### MEETING AGENDA OF THE CLEARFIELD CITY PLANNING COMMISSION

**SUBJECT:** Discussion and Possible Action on **FSP 2019-120020**, a final subdivision plat request by Jason Hamblin with Hamblin Investments for a 30-Lot single-family subdivision at the subject properties. **Location:** Approximately 741 West 300 North (TIN: 12-019-0030, 12-019-0029, & 12-019-0121). **Total Project Area:** Approximately 10.605 Acres. **Zone:** R-1-8 (Residential). **Planner:** Brad McIlrath (**Administrative Action**).

Attn: Brad McIlrath, Senior Planner  
Proj: **Hamblin Estates Subdivision**  
Subj: Review #2

**SUBJECT:** Discussion and Possible Action on **SP 2019-120020**, a site plan proposal by Matthew Perry to construct a 2,256 square foot Sips Coffee Shop at the subject property. **Location:** 1338 S. State Street (TIN: 09-245-0003). **Parcel Area:** 0.39 Acres. **Zone:** C-2 (Commercial). **Planner:** Brad McIlrath (**Administrative Action**).

Hamblin Estates Subdivision  
Phase 1  
CLEARFIELD CITY, DAVIS COUNTY, UTAH  
Cover/Index Sheet

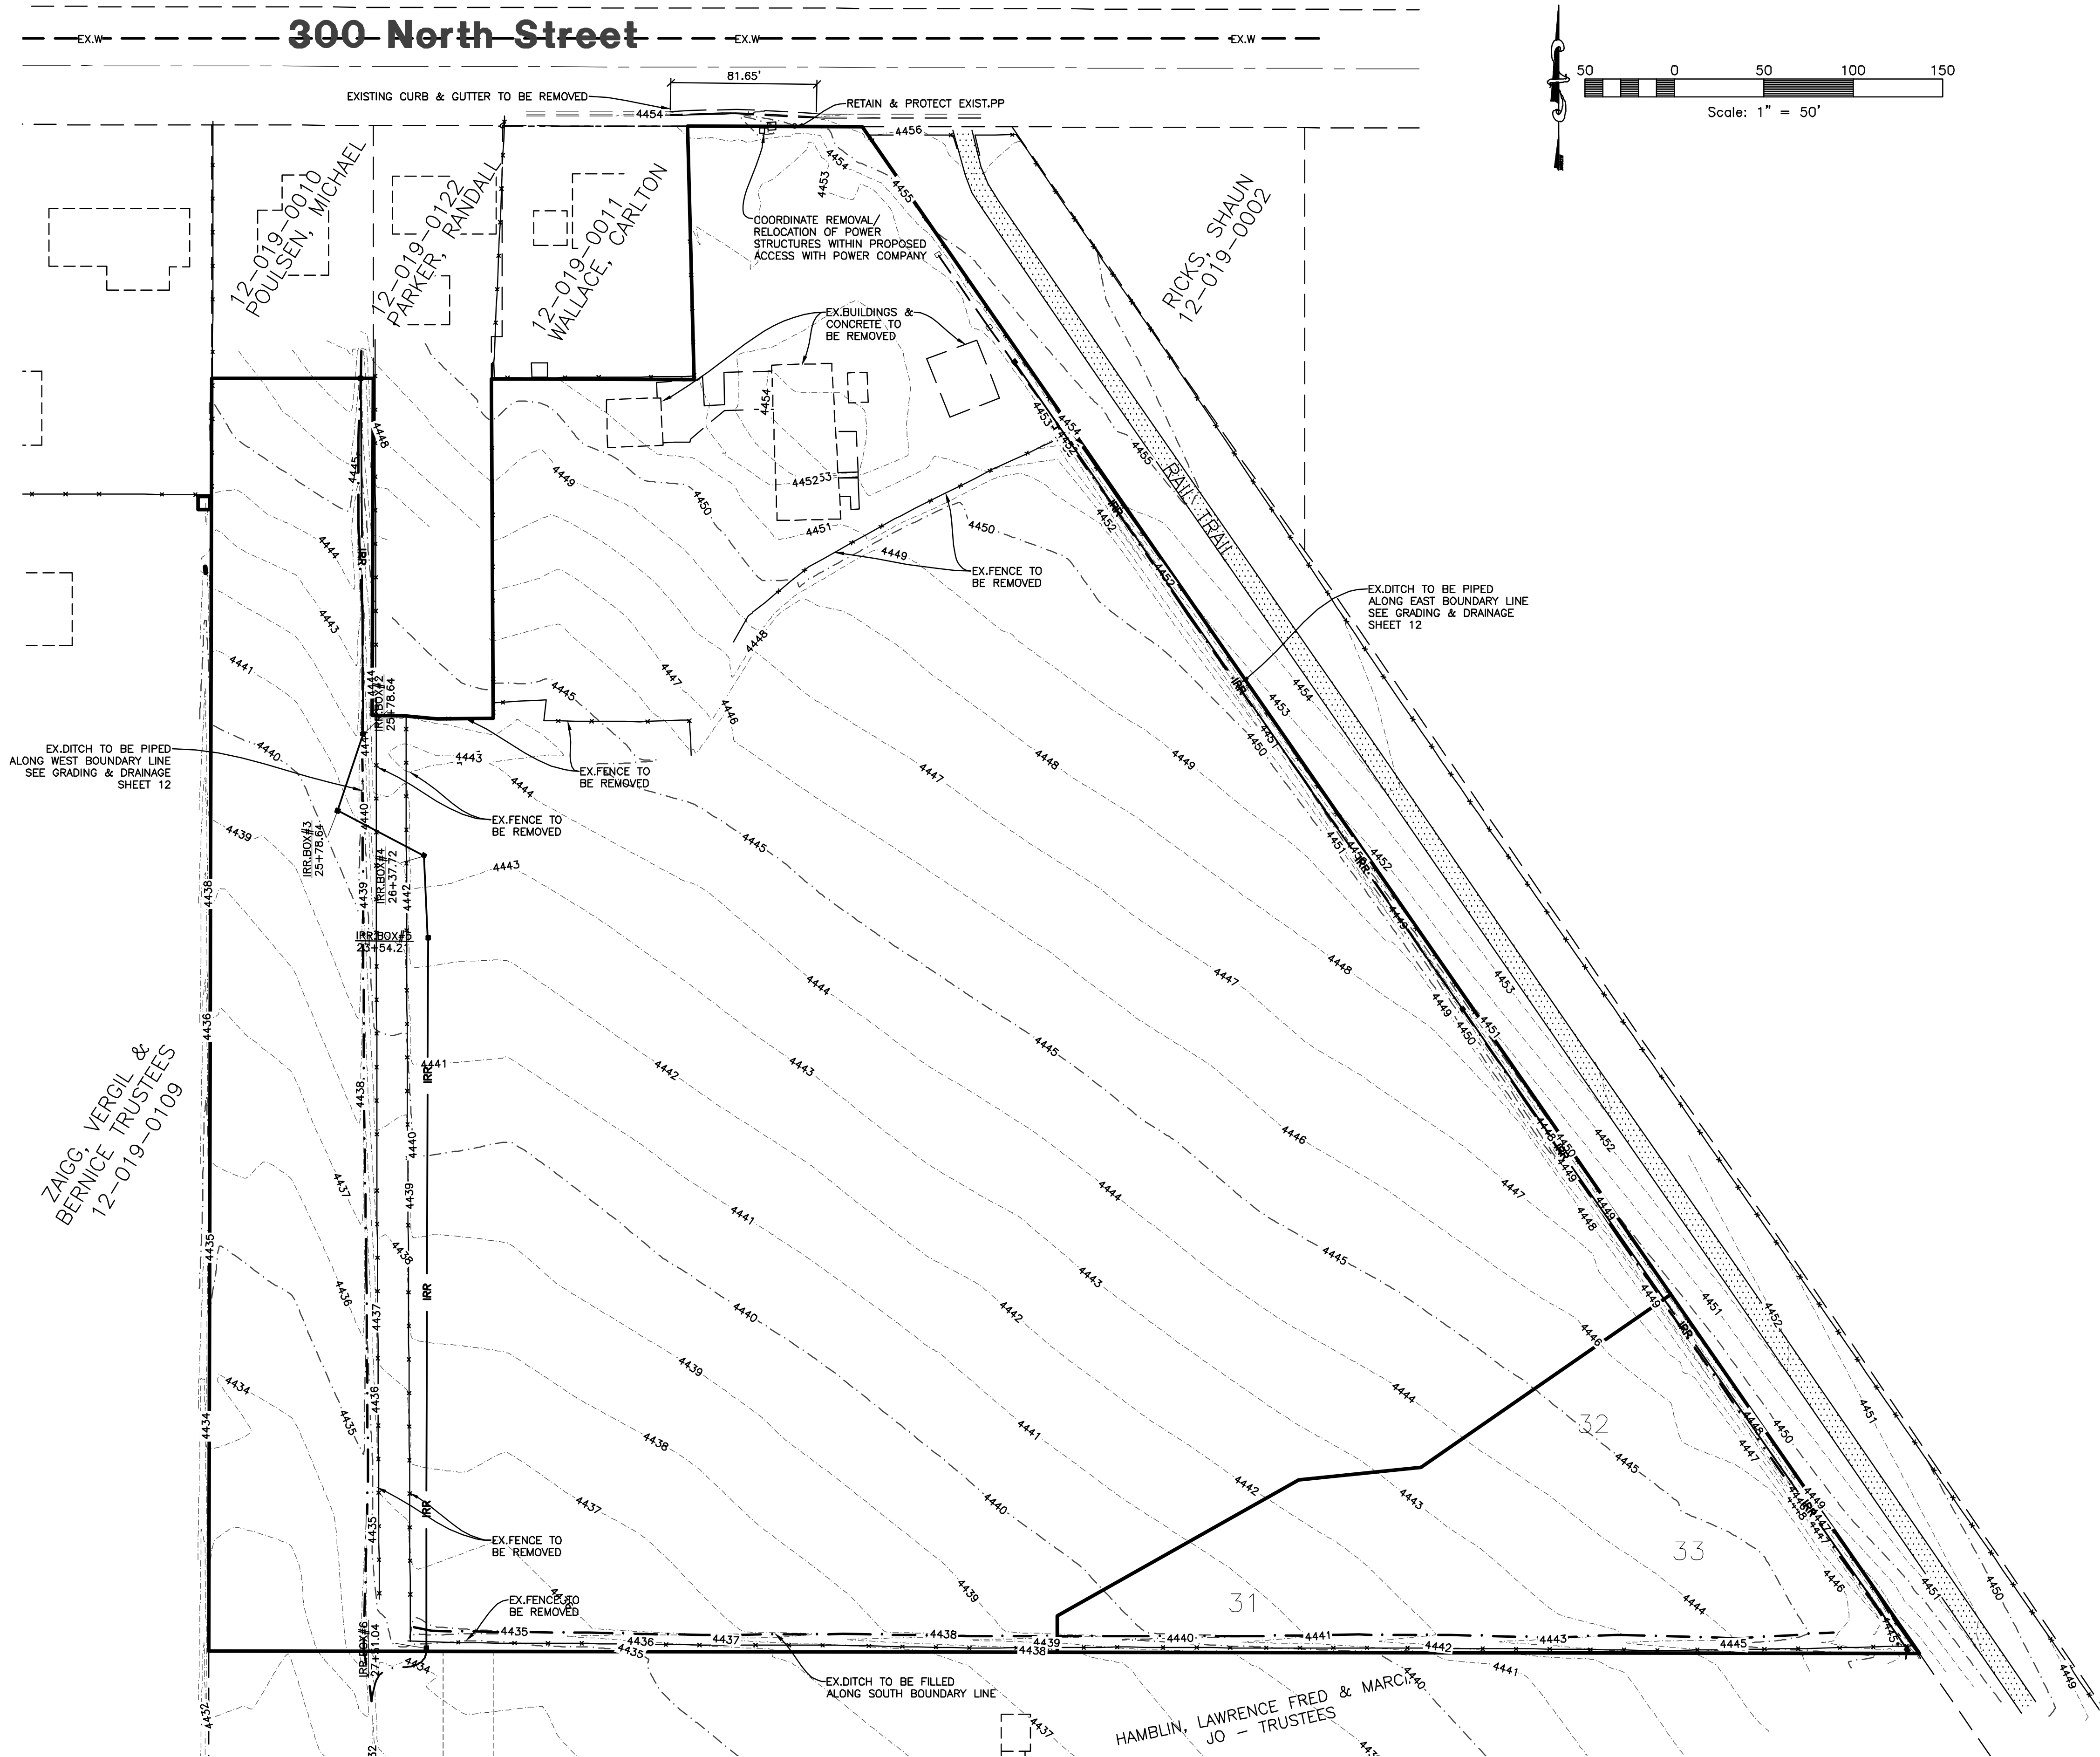
5. Easement for the irrigation piping also need to be placed on the Plat.
6. The Plat needs the following information added:
  - All streets need to be addressed with a number.

6. There are several fire hydrants which need the gate valve moved to the tee connection rather than mid-point or as a foot valve. Show the closest fire hydrant along 300 North Street.

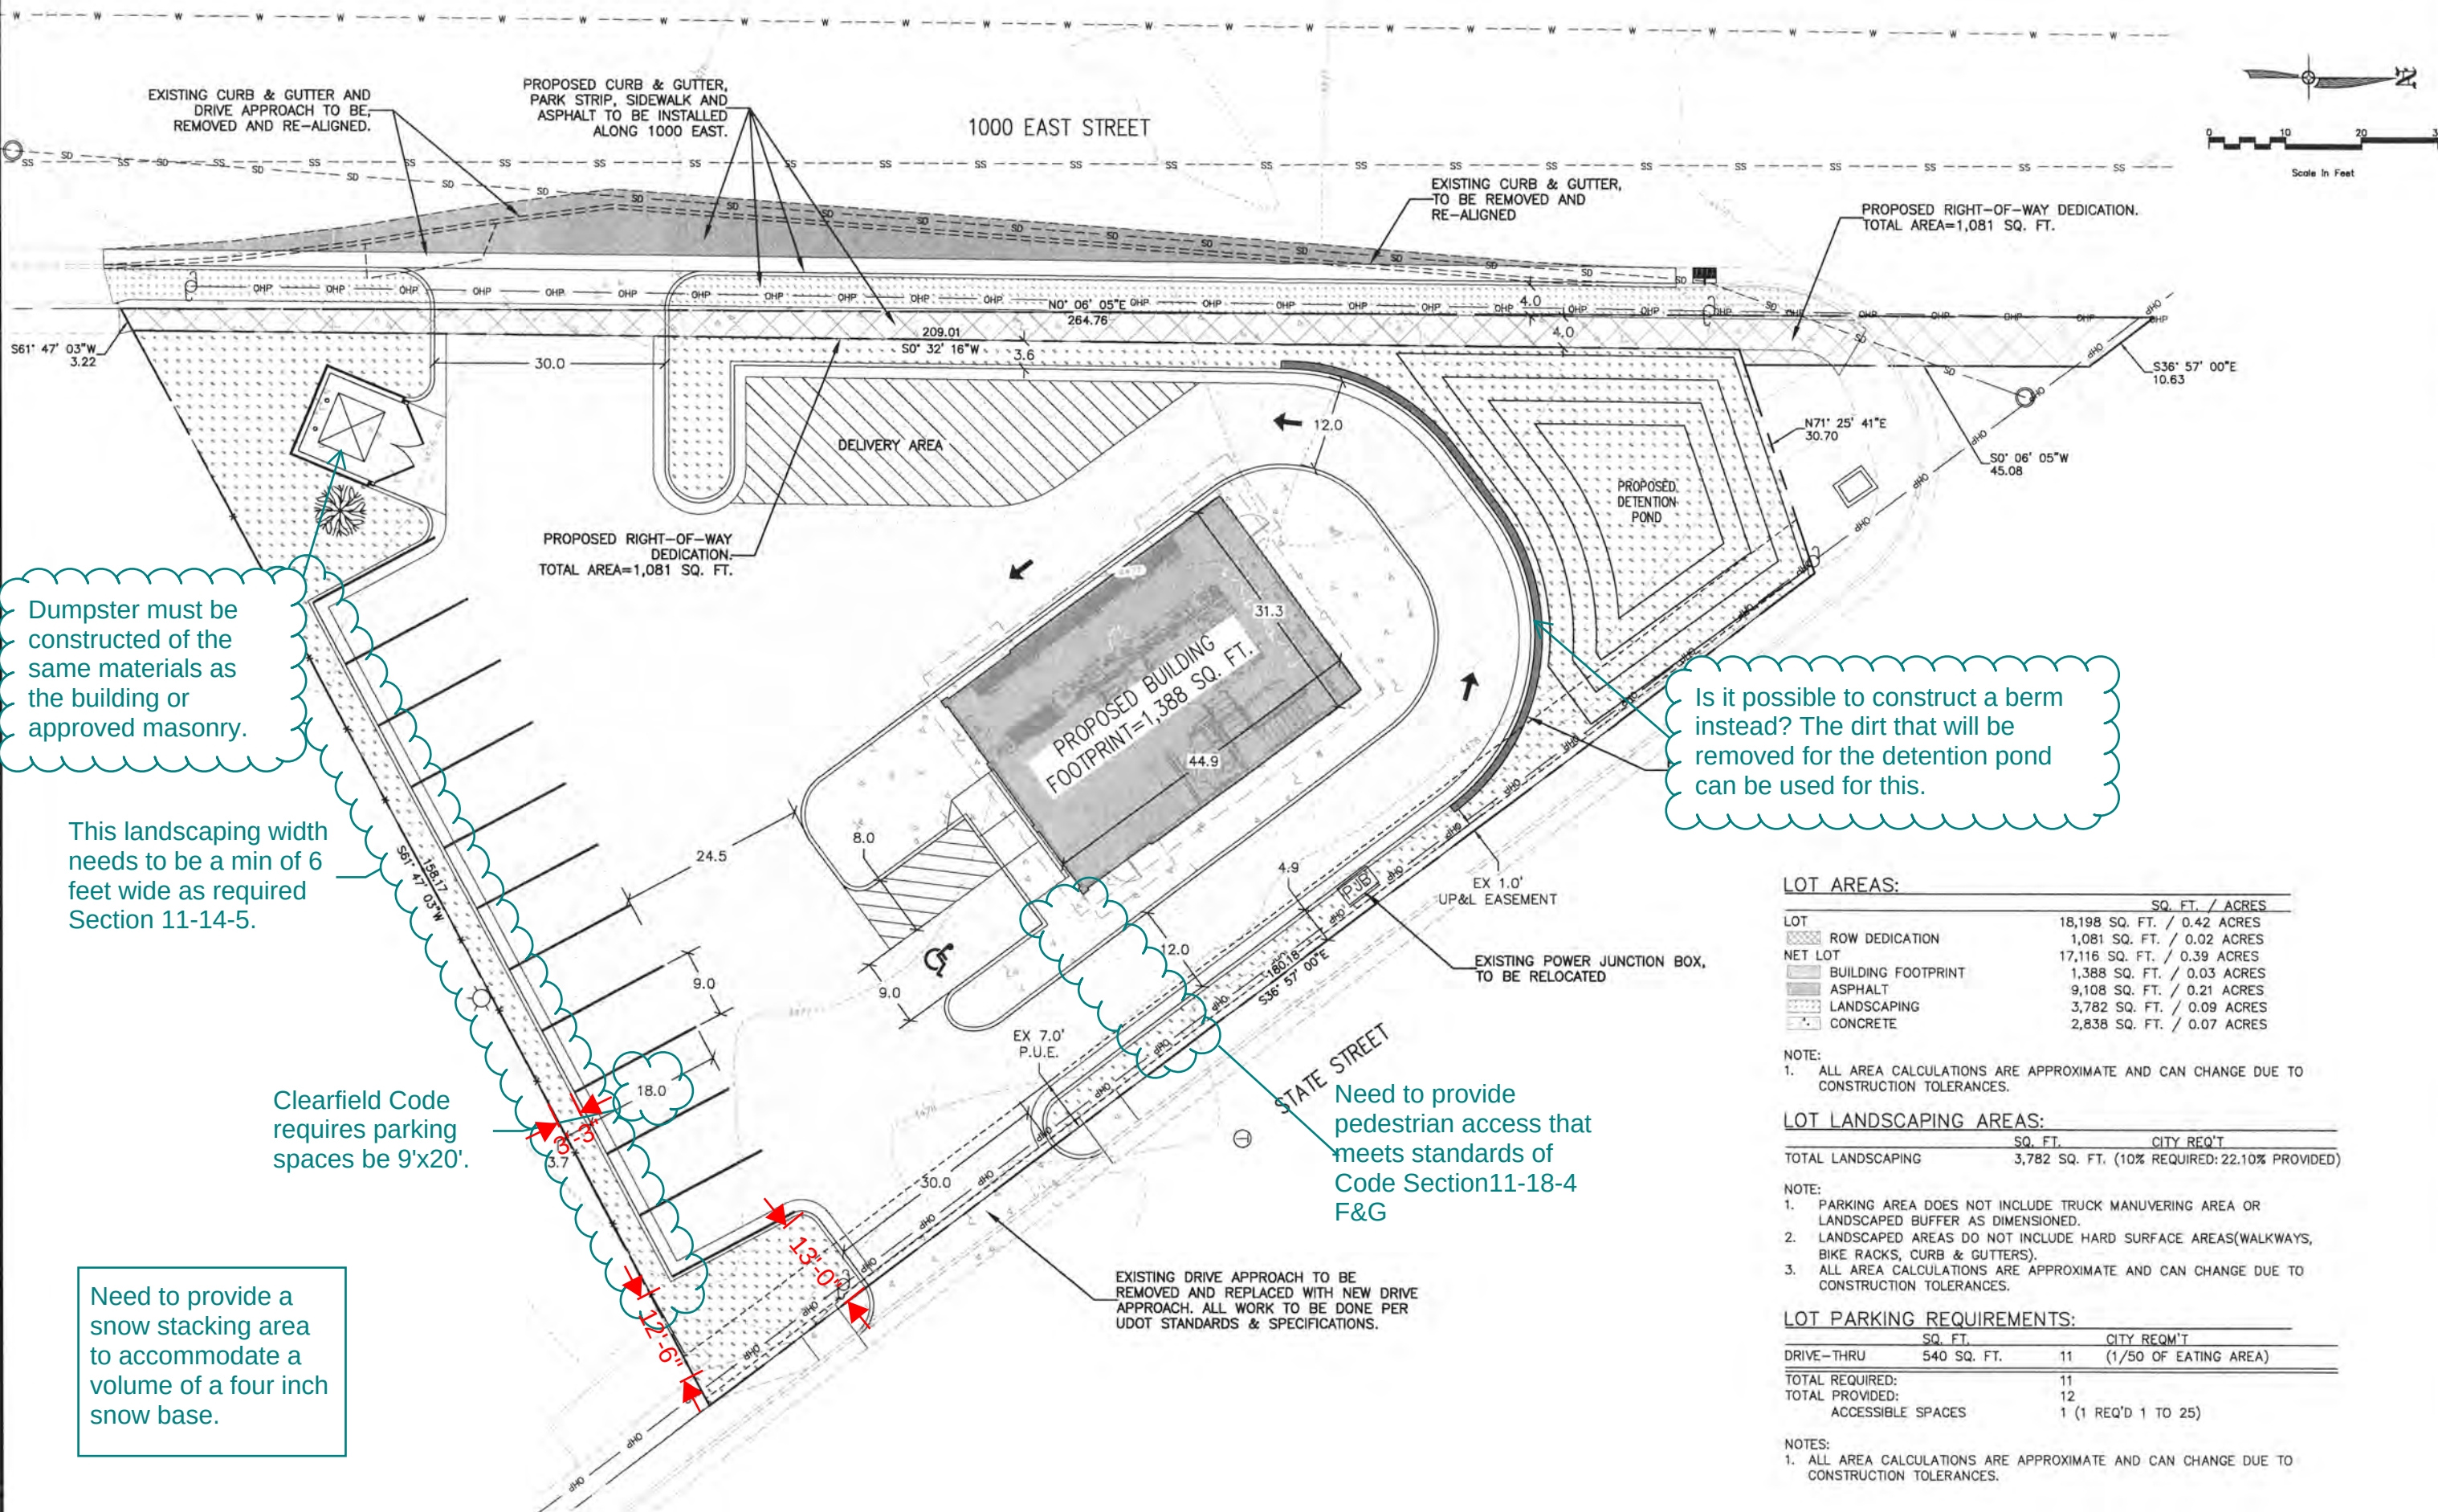
6. The driveway access width shown on drawing A001 is different from the site plan drawing of C1. These need to be the same width.
